## **Delegated Report**

**Subject:** Wimbledon Area Traffic Model

- 2.1 The purpose of this report is to inform the Cabinet Member for Planning and Traffic Management of the outcome of the statutory consultation on 'The Wimbledon Area Traffic Study' conducted in February and March 2010.

Z36-24-10-2 ST MARY'S RD/ARTHUR RD JUNCTION TABLE

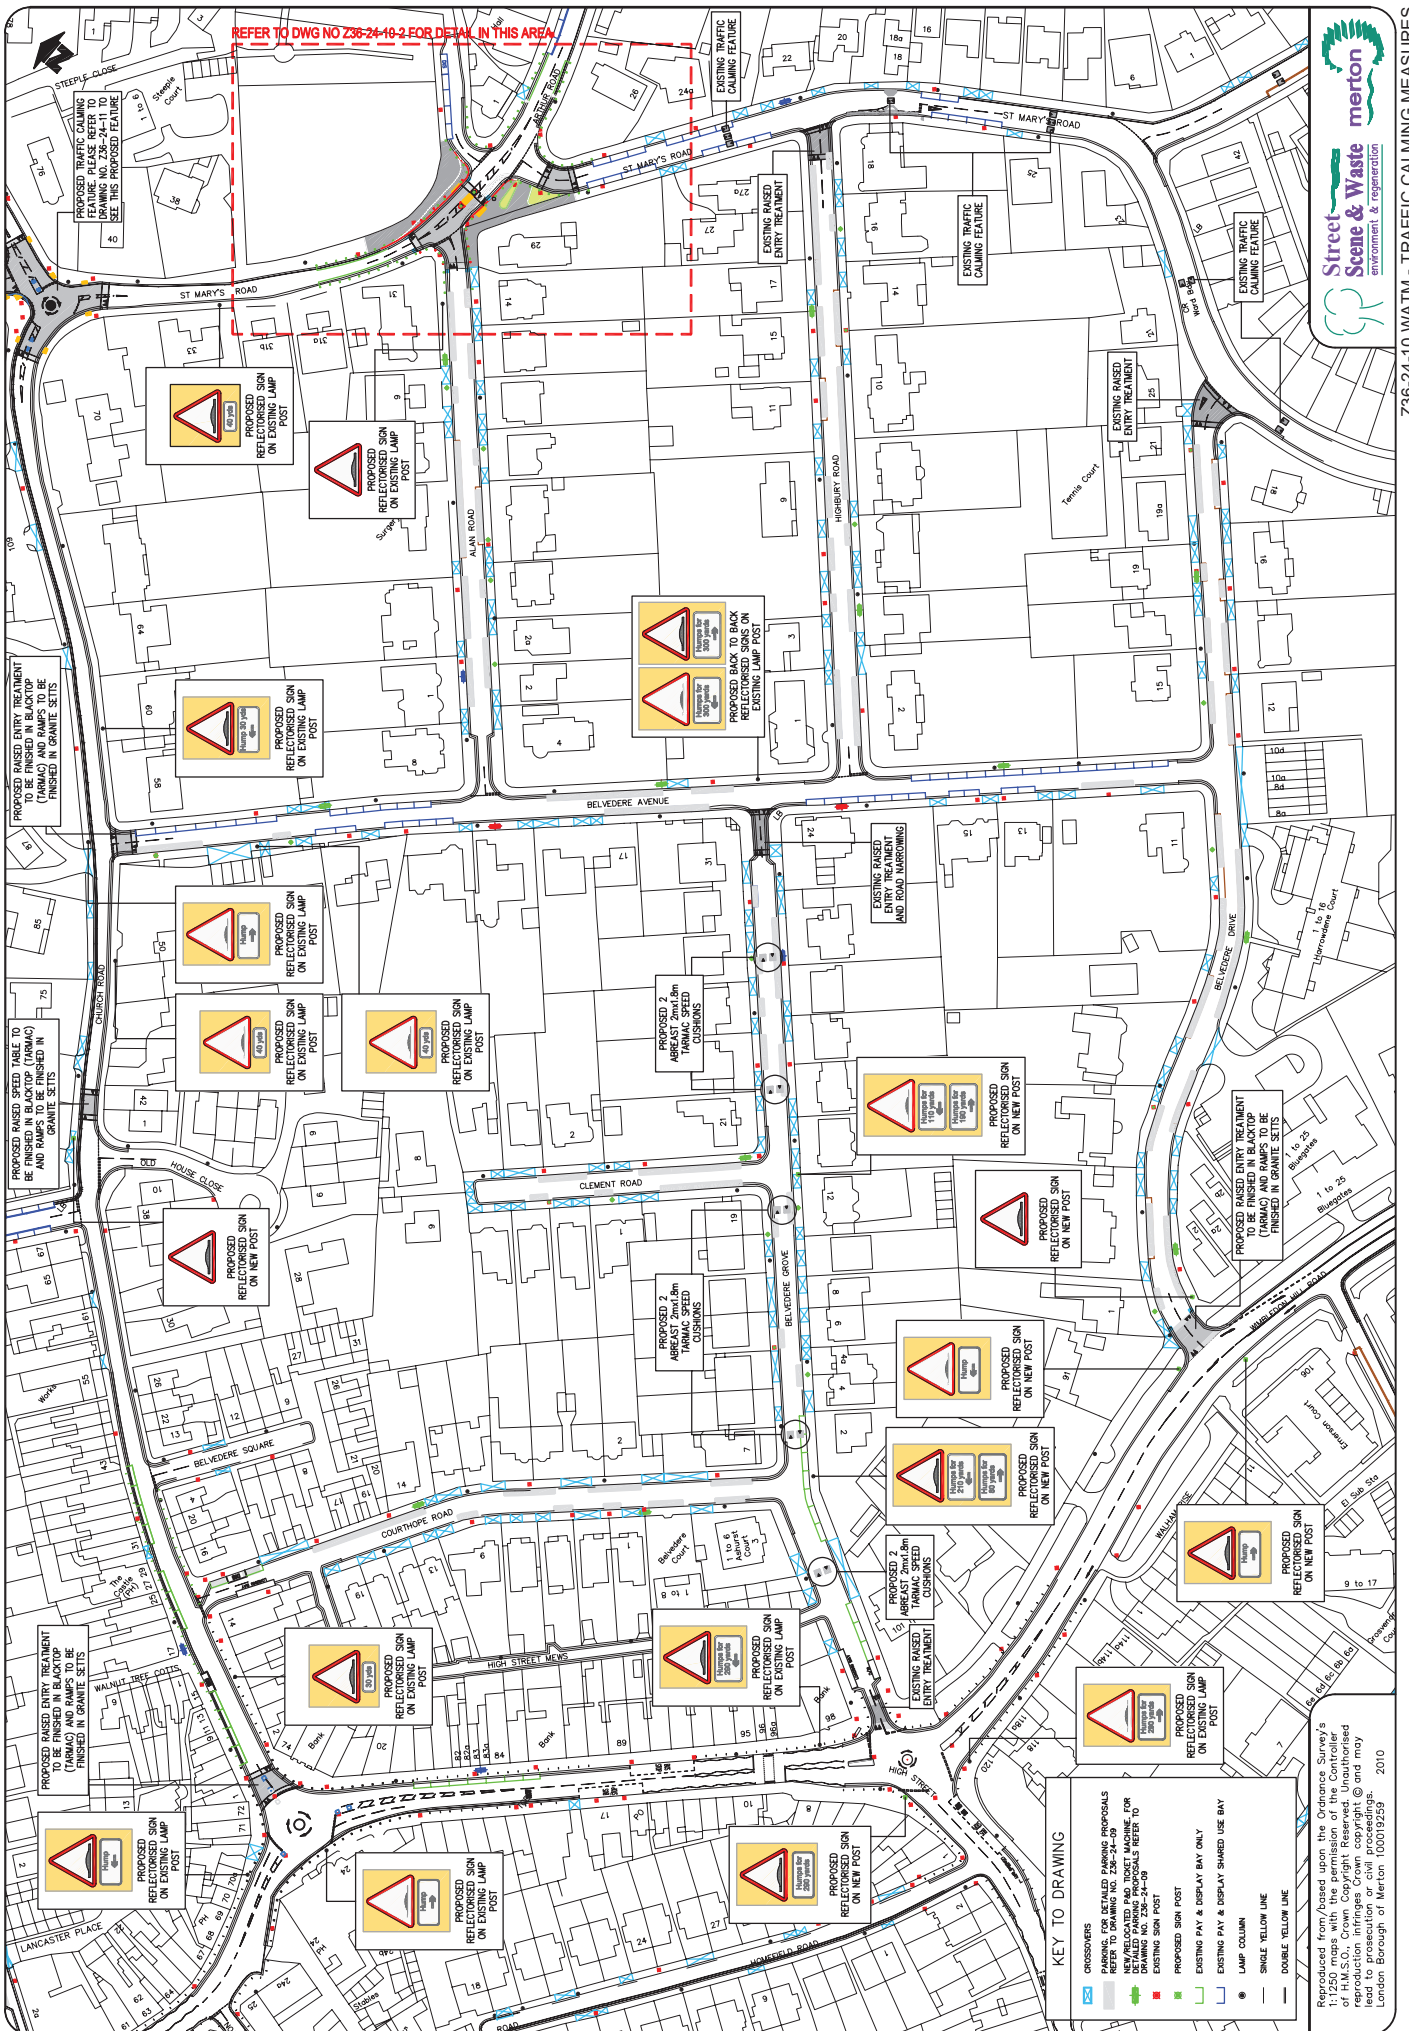
4. I question the proposed re-arrangement of the junction St Mary’s Road/Arthur Road /Alan Road, (Z36-24-10-2) to replace the existing mini-roundabout arrangement, with give way priorities, which seems complicated, but actually works well and safely and reduces speeds. The proposed arrangement looks neater but should be investigated further as it would seem to be likely to actually cause more congestion and not reduce speeds! The same may apply to the Church Road/St Mary’s Road junction, (Z36-24-10), which also seems to work safely enough. Why go to the expense of altering them when they work!

Option 1 – Agree to proceed with the changes to the junction priorities and replace existing mini roundabouts with a raised speed table.

Z36-24-10 WATM - TRAFFIC CALMING MEASURES

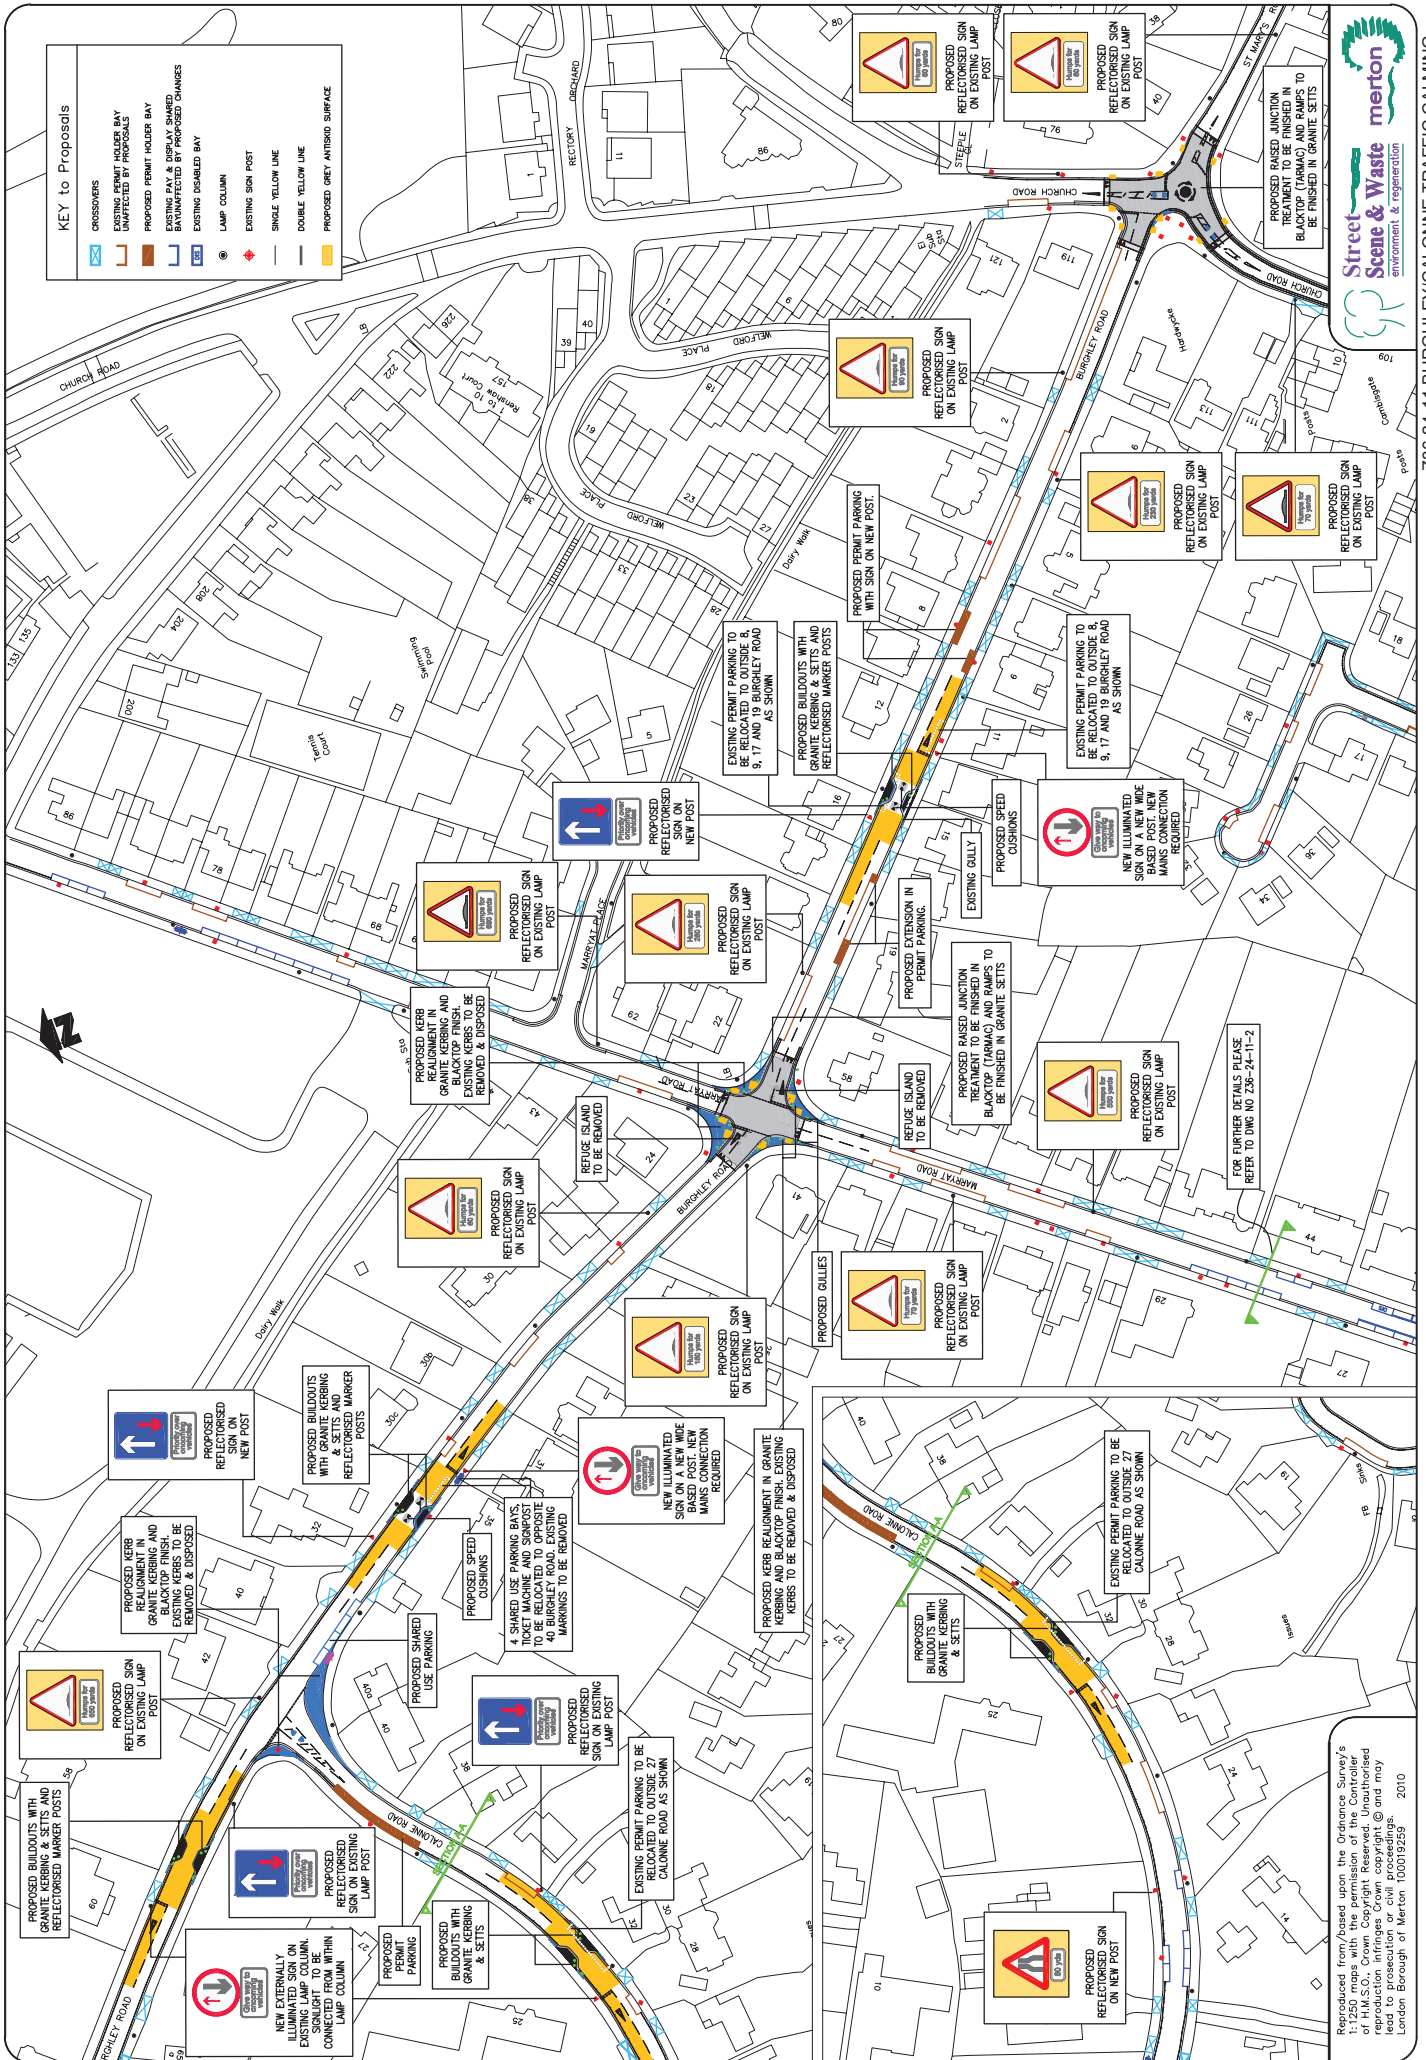
Regarding speed cushions/raised treatments within the general area - I feel that they will do little to slow existing traffic and will add to the noise and pollution within the Belvedere area, without lessening the volume of larger vehicles, passing through, whose suspension is more than able to cope with them without any inconvenience to the driver.

Z36-24-12 : 20MPH SPEED LIMIT AREA

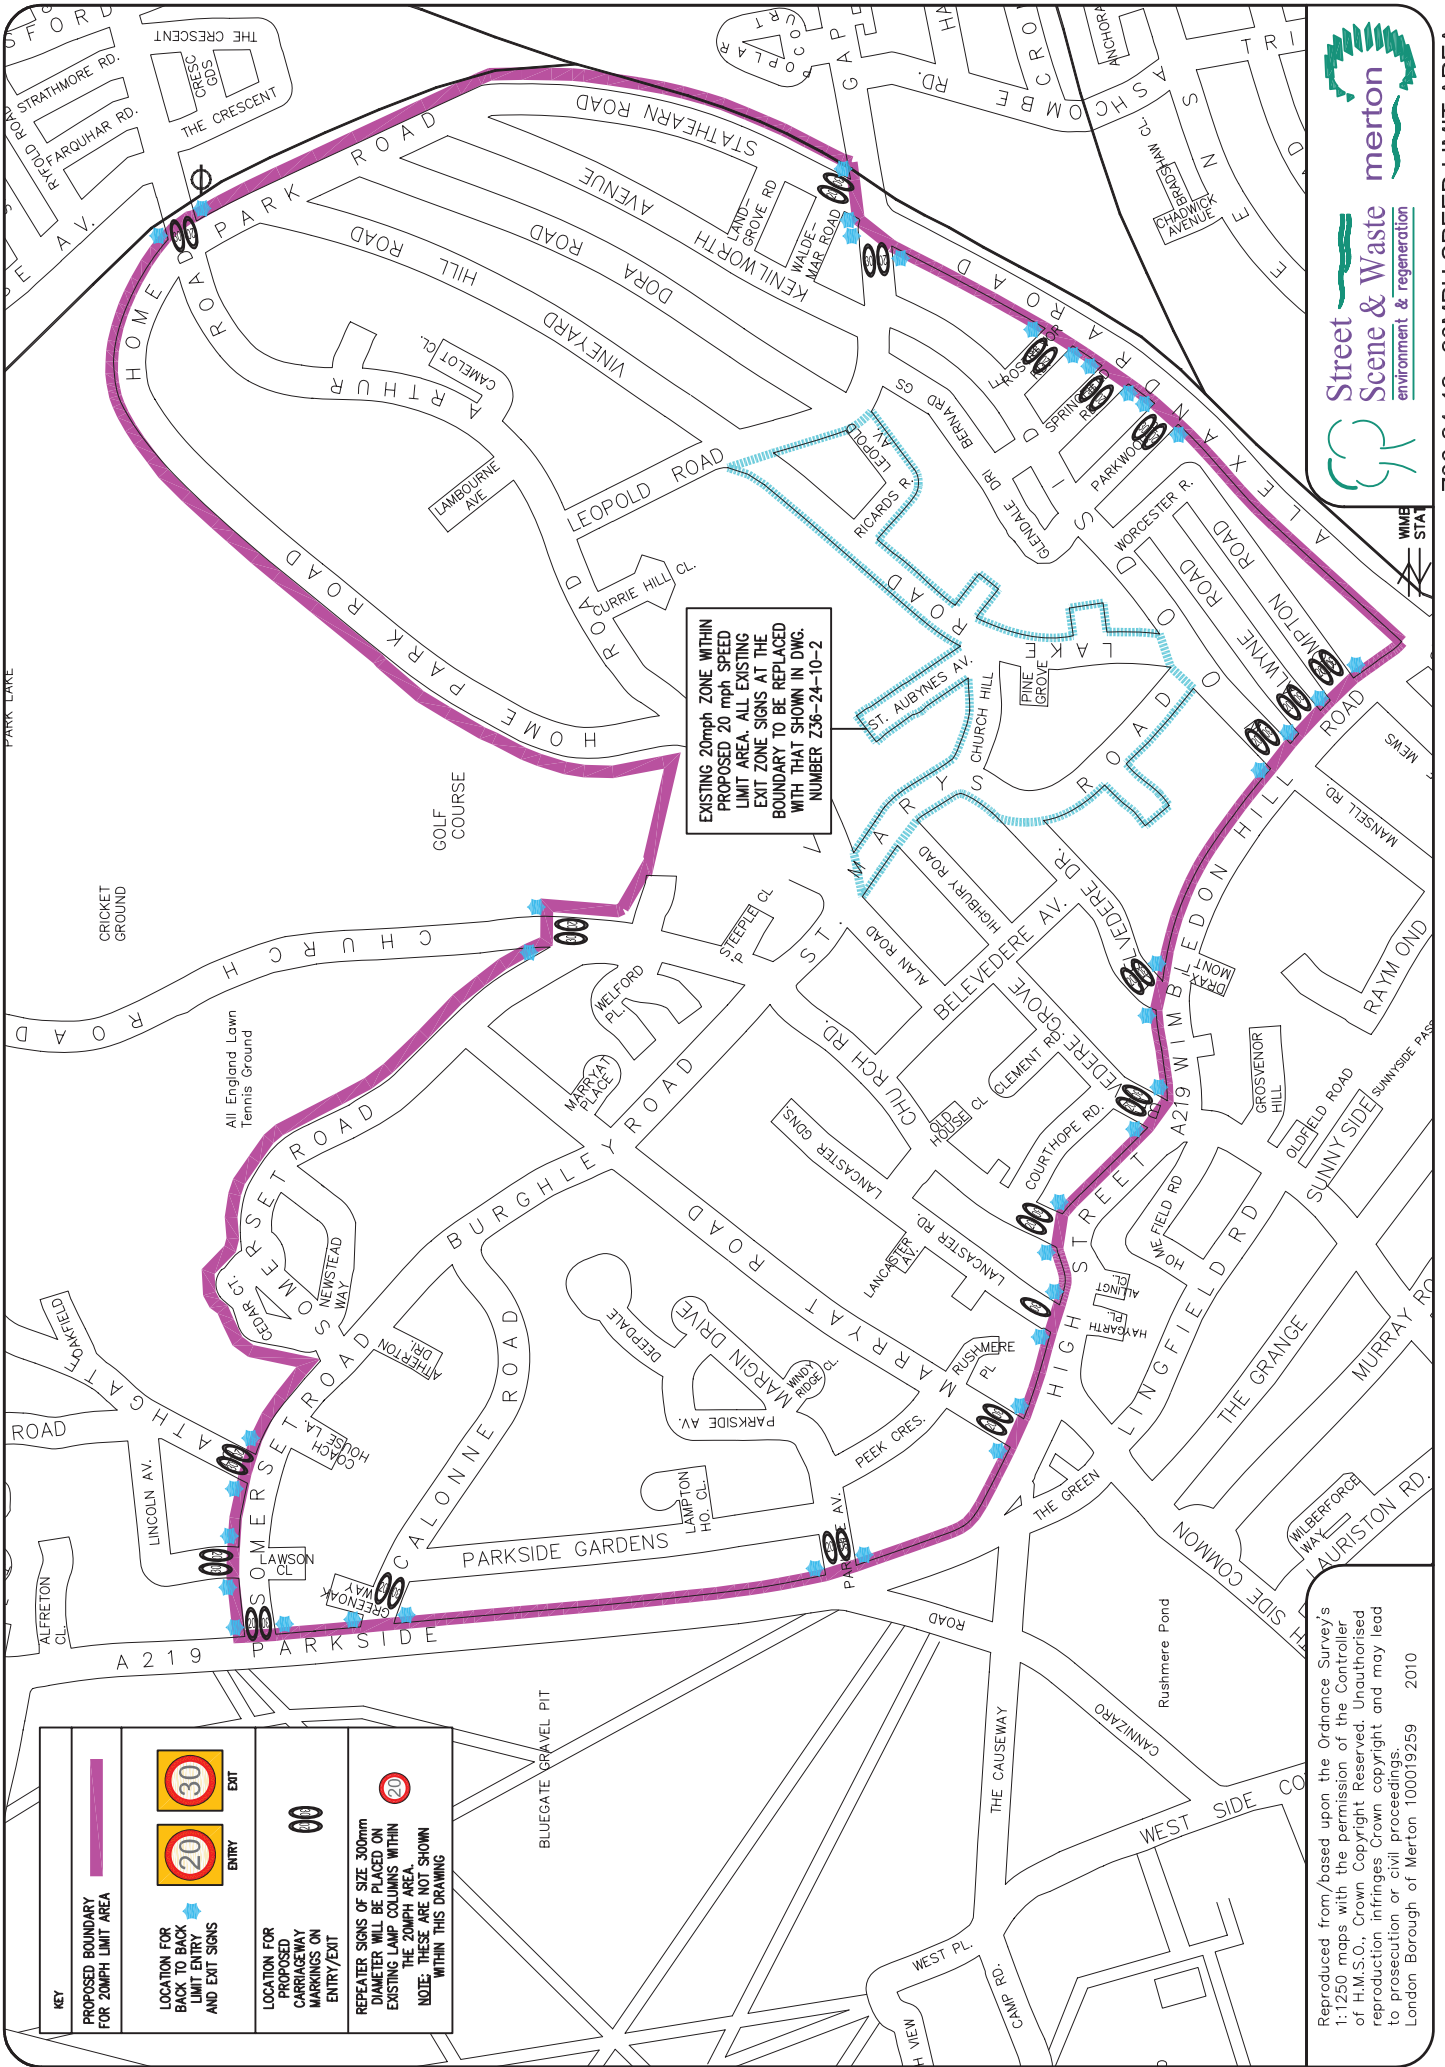
I disagree with the proposal for a 20 mph speed limit in the area shown on Drawing No Z36-24-12 because:-

I support the introduction of a 20 mph speed limit throughout the area shown on drawing Z36-24-12, provided that it is monitored and enforced by police action rather than by speed cushions, raised entry features and the like.
